The Commons at Falcon Field - Deviations

- Deviation No. 1 - Intersection Spacing Along a Collector
- Deviation No. 2a - Access to a Collector Street
- Deviation No. 2b - Right-In-Only Access to a Collector
- Deviation No. 3 - Turn Lane Lengths

DEVIATION REQUEST AND DECISION FORM

Project Name : The Commons at Falcon Field Deviation No. 1 Date: 11/27/2023

Deviation Exhibit A

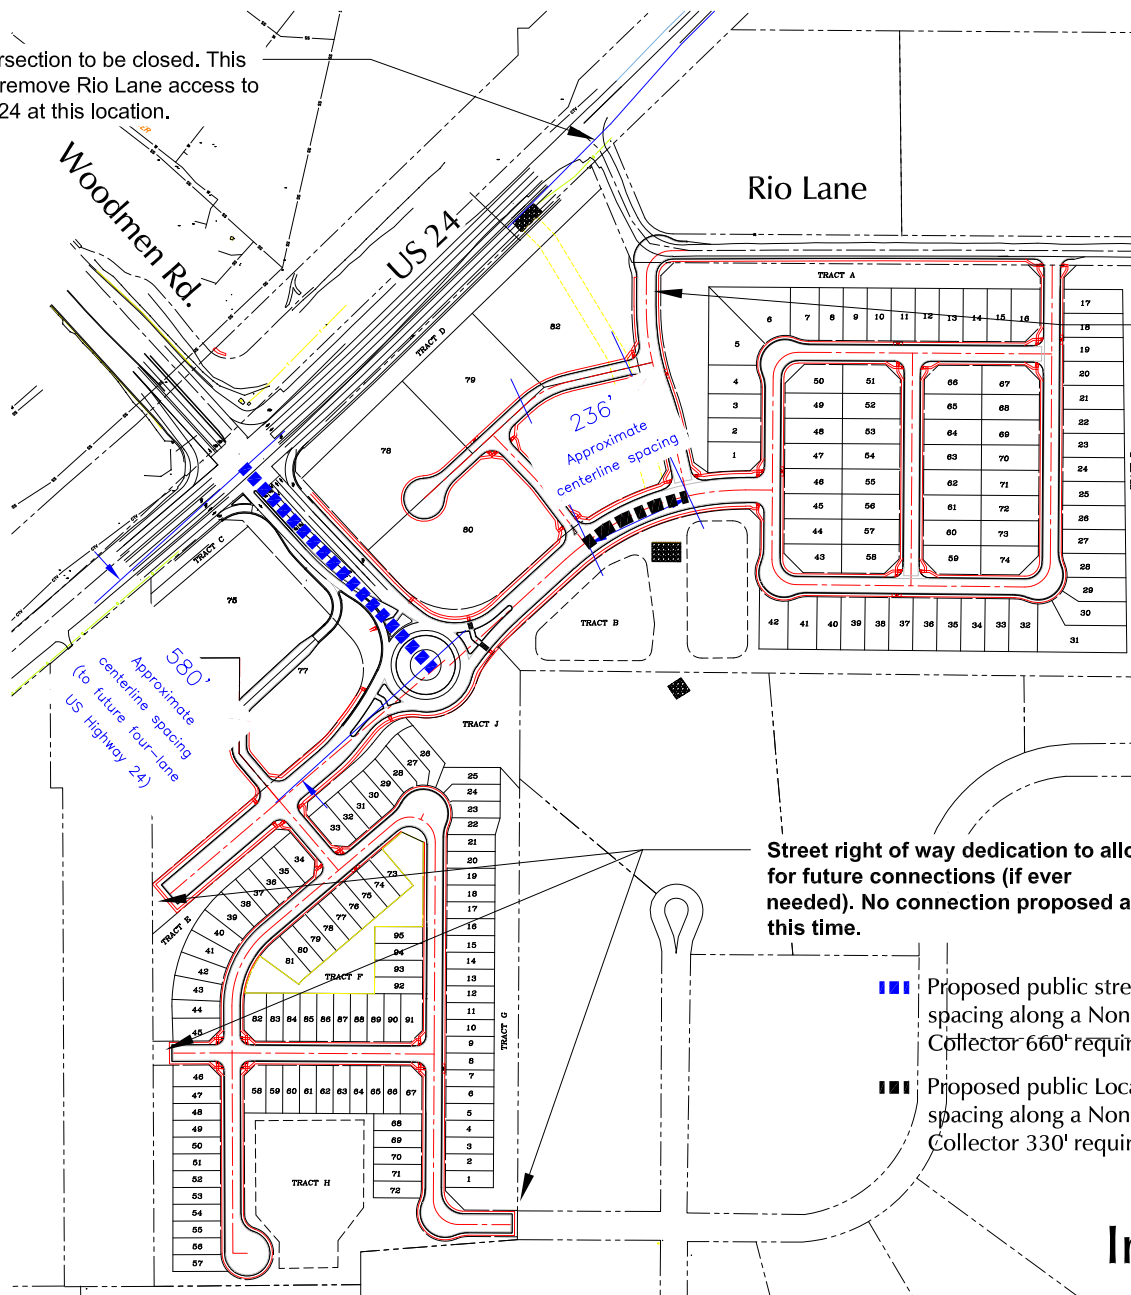
HWY 24?

<p>County approvals are conditional on CDOT approval.</p>

Deviation Exhibit 1-1 Intersection Spacing

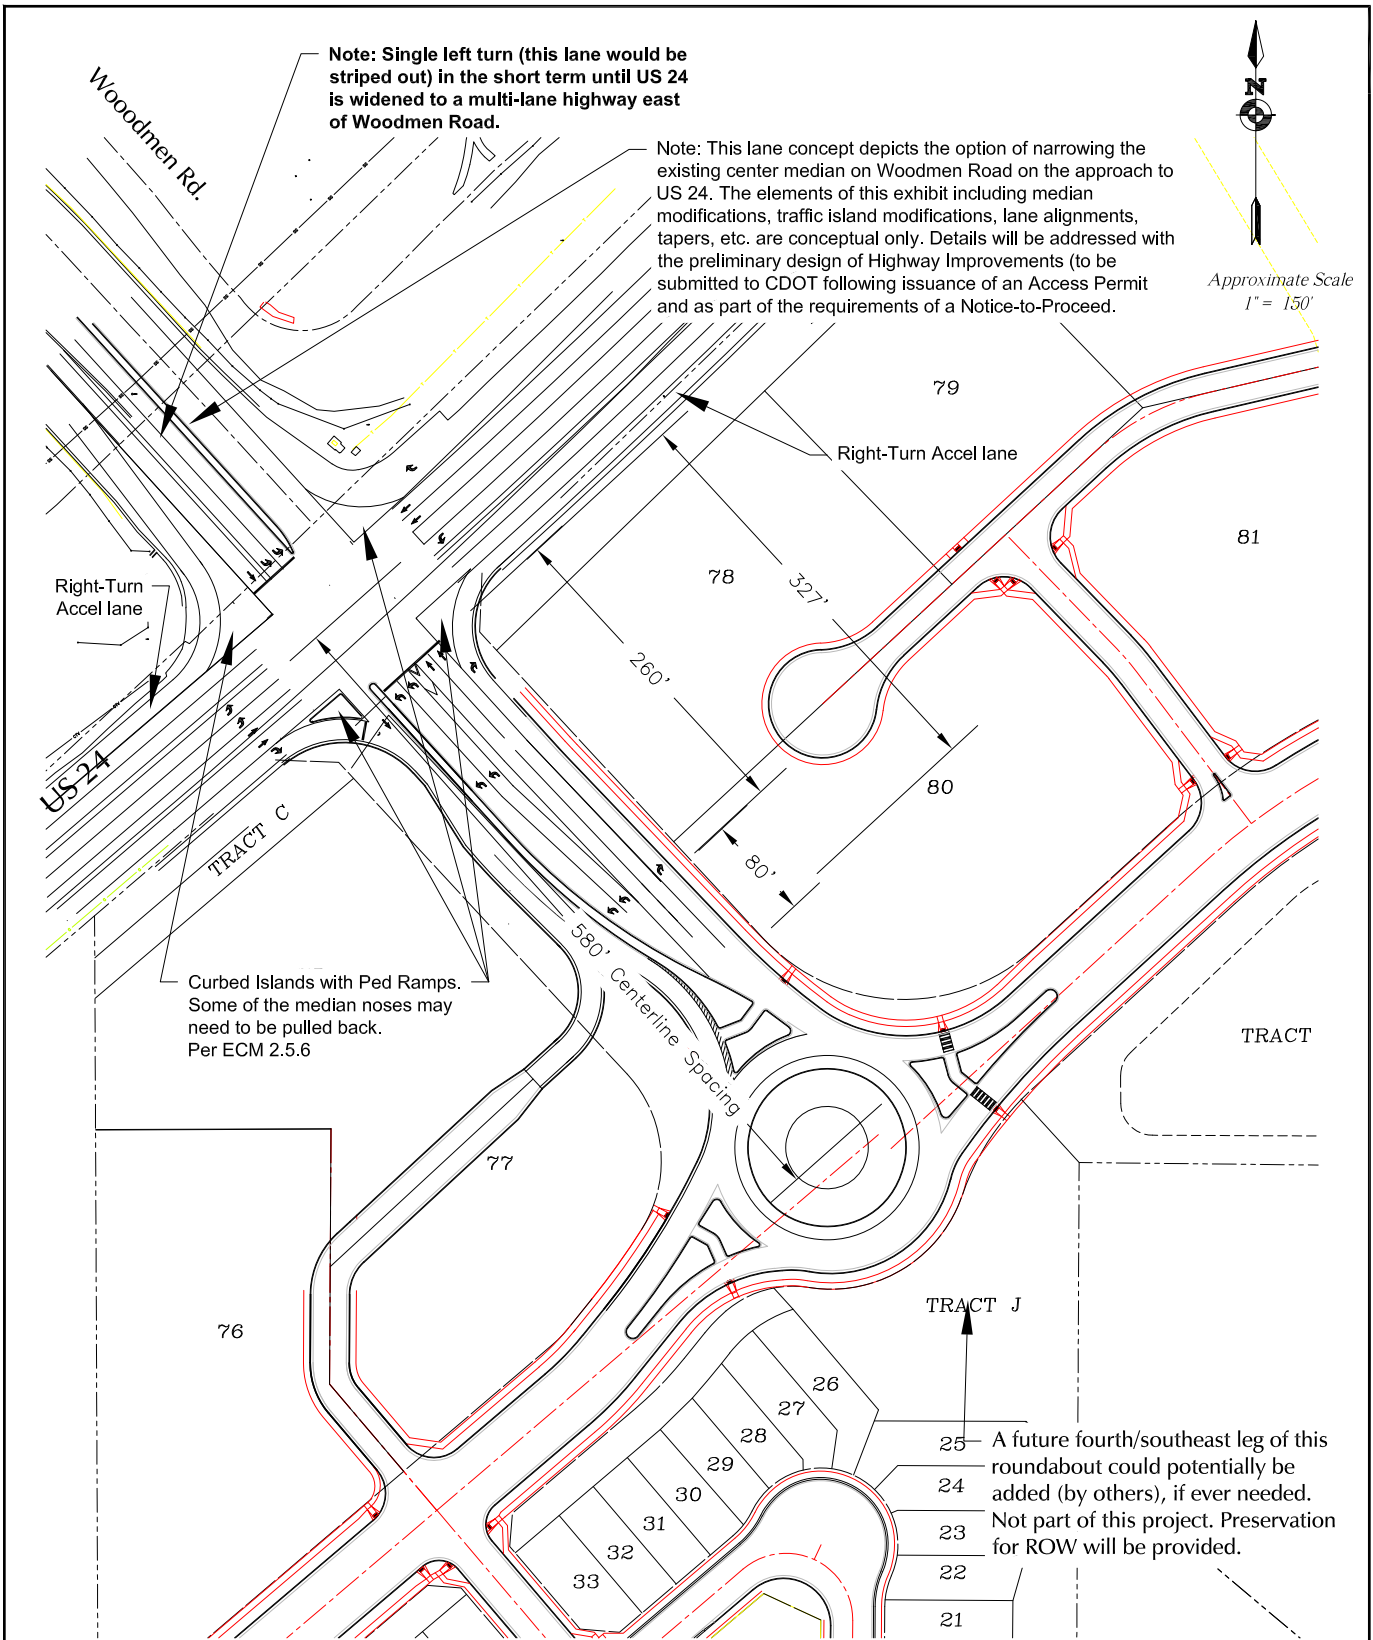
- ■ ■ Proposed public street intersection spacing along a Non-residential Collector 660' required, 580' proposed.
- ■ ■ Proposed public Local street intersection spacing along a Non-residential Collector 330' required, 236' proposed.
